**BIDDING ADDENDUM NO. 1**

**PARTIAL REROOFING FOR:**

**DUTCH VALLEY ELEMENTARY SCHOOL**  
1044 OLD DUTCH VALLEY ROAD  
CLINTON, TENNESSEE 37716

**LAKE CITY ELEMENTARY SCHOOL**  
402 LINDSAY AVENUE  
ROCKY TOP, TENNESSEE 37769

**(A) REVISED WALL FLASHING DETAIL**

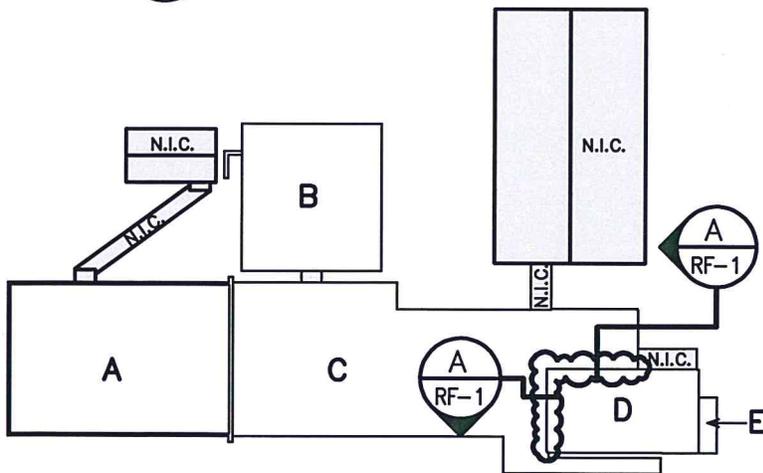
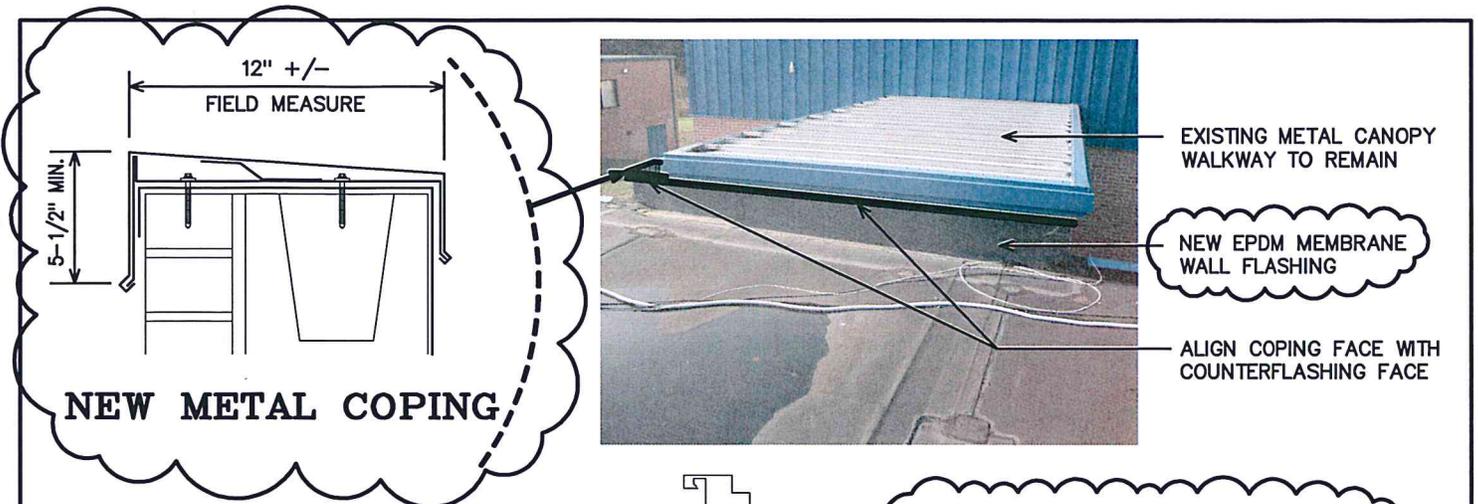
1. Detail A1/R1.1: Revise wall flashing detail between Roof Areas "C" and "D". See attached RF-1 Drawing – Detail A. (EPDM wall flashing to completely cover the wall).

**(B) REVISED WALL FLASHING DETAIL**

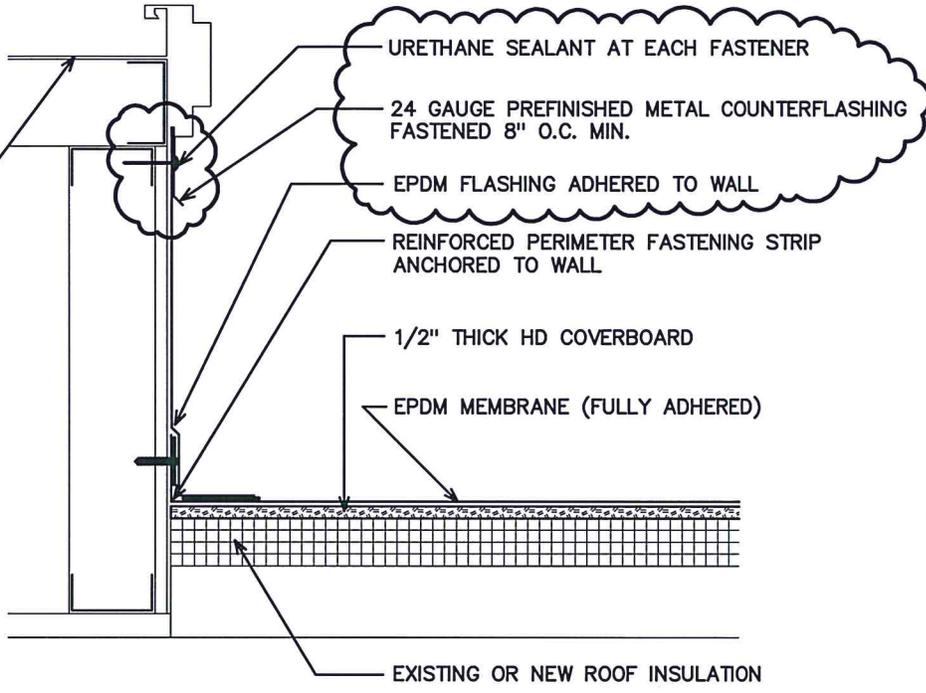
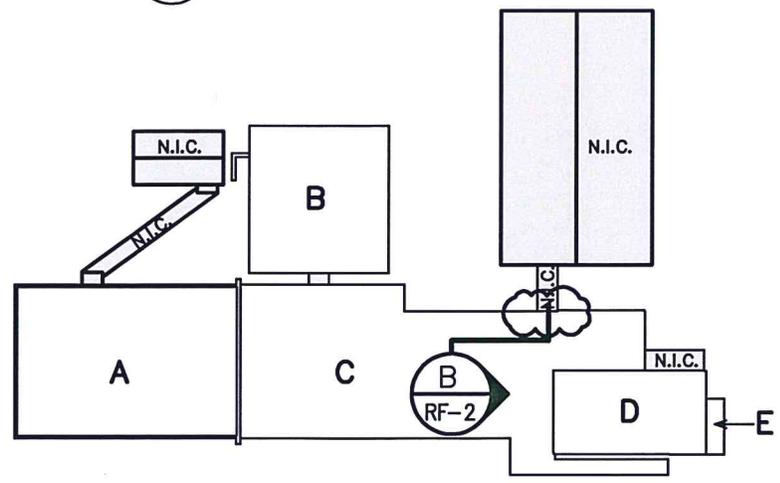
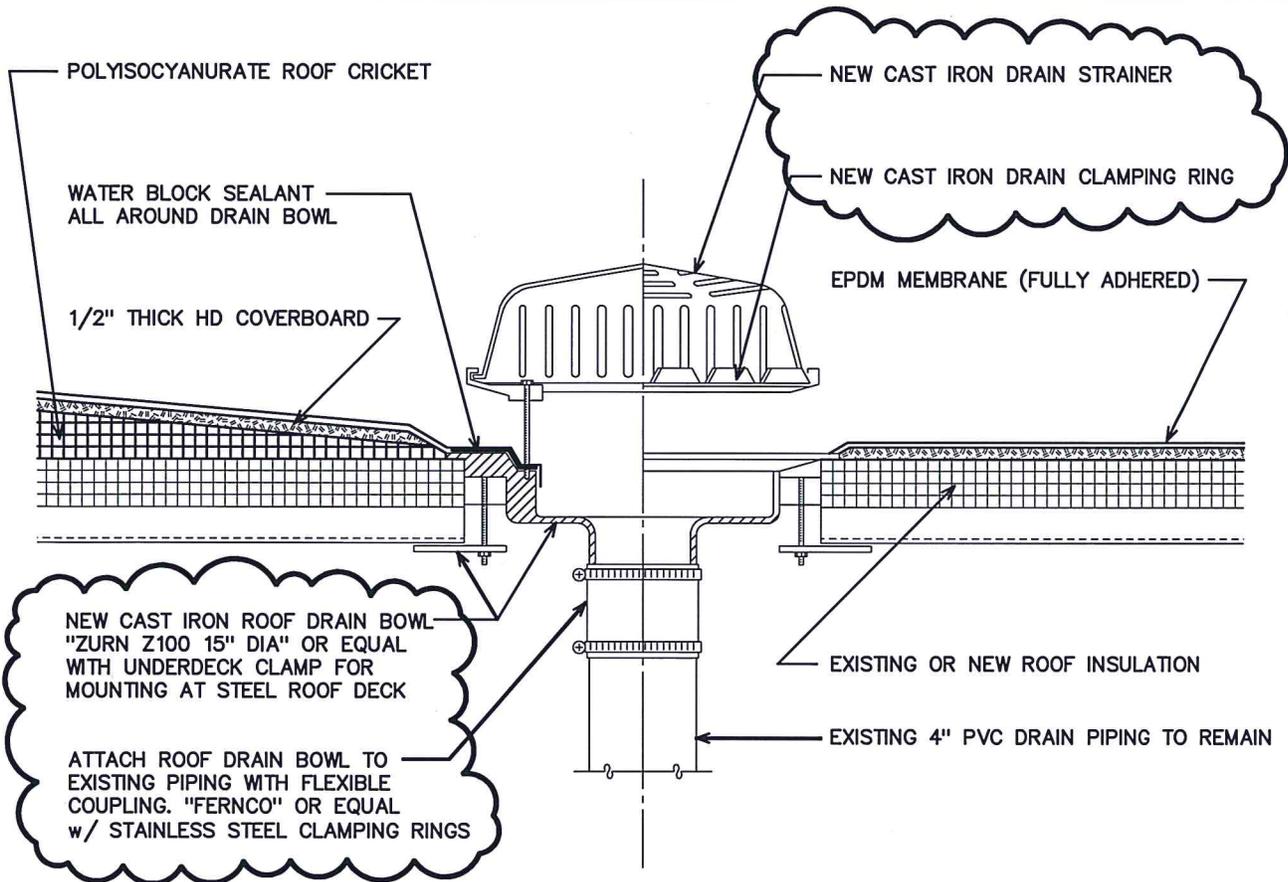
2. Detail A1/R1.1: Revise wall flashing detail between Roof Areas "C" and "Canopy Walkway to Gymnasium". See attached RF-2 Drawing – Detail B. (New EPDM wall flashing in lieu of reusing existing. Terminate new EPDM wall flashing with prefinished metal counterflashing). Install new prefinished metal coping at canopy bumpout. Align coping face with new prefinished metal counterflashing.

(C) NEW ROOF DRAIN & STRAINER AT AREA "A"

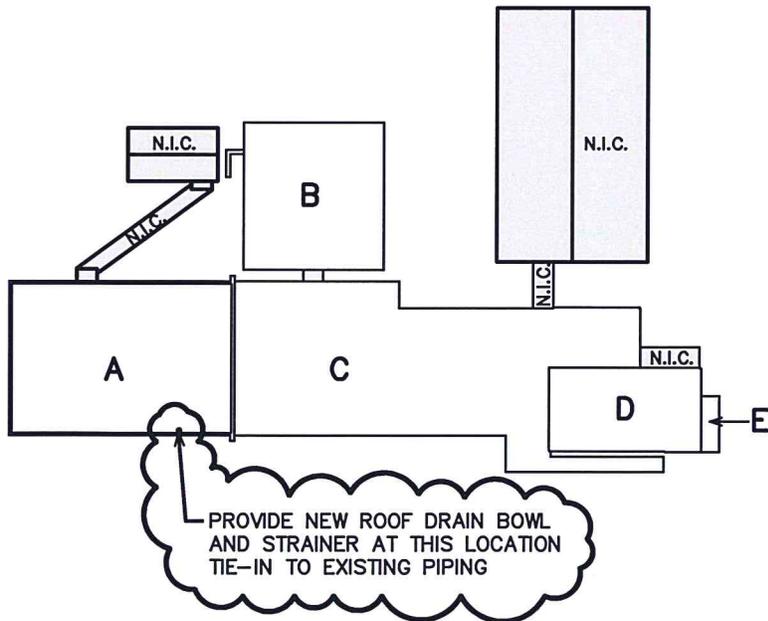
3. Detail A1/R1.1: Provide and install one new roof drain bowl and strainer at Roof Area "A". See attached RF-3 Drawing – Detail C for location. Attach new roof drain bowl to existing steel deck with underdeck clamp. Attach new roof drain bowl to existing 4" PVC piping with flexible coupling and stainless steel clamping ring.
